Service Bulletin

GM Bulletin No.: 14450 Date: July 2014

Inspect Air Conditioning Refrigerant Warning Label

MODELS: 2015 Cadillac Escalade Models

Example of Air Conditioning Refrigerant Warning Label with 0.92 kg Correctly Displayed

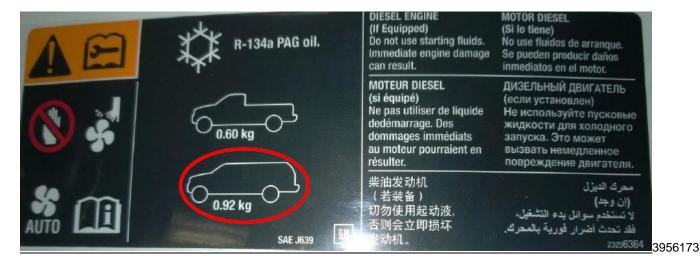
- 1. Open the hood and inspect the air conditioning (A/C) refrigerant warning label shown above to ensure that it is correct.
 - If the refrigerant charge is listed as 0.92 kg as shown above, the air conditioning (A/C) refrigerant warning label is correct and no further action is required.
 - If the refrigerant charge is NOT listed as 0.92 kg, it is incorrect. Proceed to step 2.

- 2. Completely recover the entire amount of original refrigerant from the air conditioning system and recharge it with the recovered refrigerant but exactly to the specified quantity of 0.92 kg only. Refer to *Refrigerant Recovery and Recharging (R-134a)* in SI.
- Replace the incorrect air conditioning refrigerant warning label using the correct label described above.
